ENGINEER'S SEAL	Discount Towing 109 Headingly Ave. NW	DRAWN BY RHD
	GRADING AND DRAINAGE PLAN	DATE 9-01-15
	RHD Engineering, LLC 4305 Purple Sage Ave. NW ALBUQUERQUE, NM 87120 (505) 288-1621	SHEET # 1 of 1
Richard Dourte P.E. #10854		JOB #

Drainage Report

Discount Towing
109 Headingly Ave. NW
Albuquerque, New Mexico

**RE: Discount Towing
109 Headingly NW
Grading and Drainage Plan
Engineers Stamp Date 9/1/15 (G15D0201)**

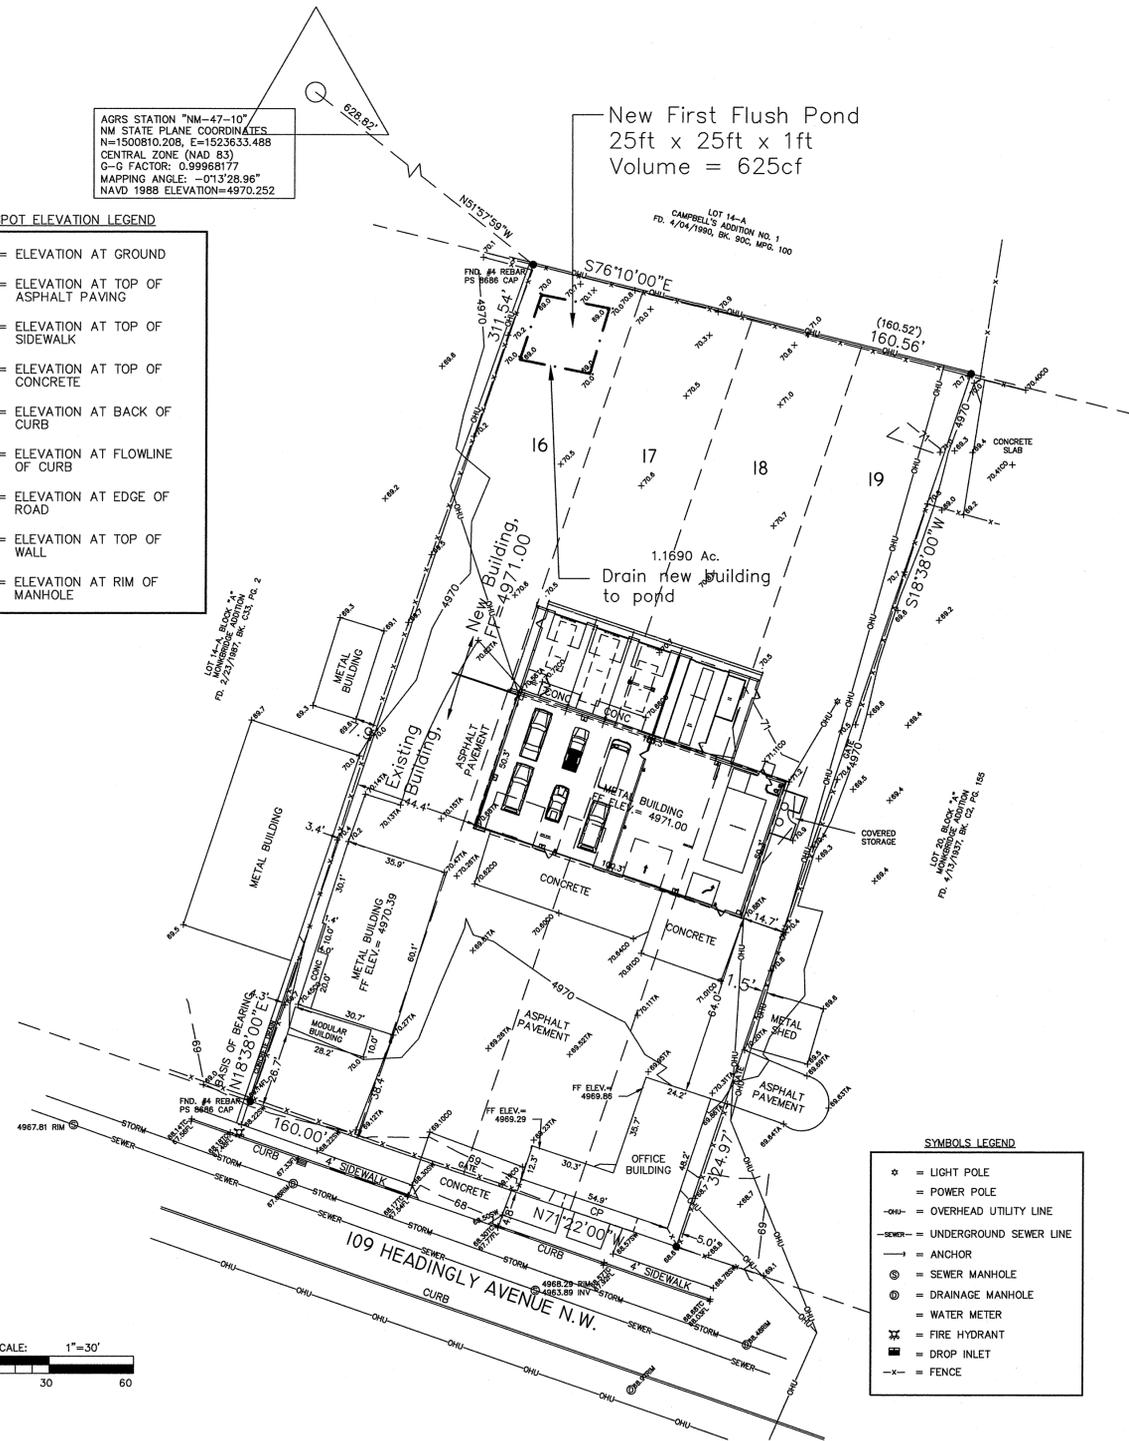
- Provide emergency overflow/calculations.
- Where does the runoff go once it exceeds its capacity?
- Provide how offsite flows are being handled.
- Provide different line weights for existing buildings and the new building.
- Clearly show proposed and existing spot elevations and topography.
- Is re-plat required for the removal of the lot lines?
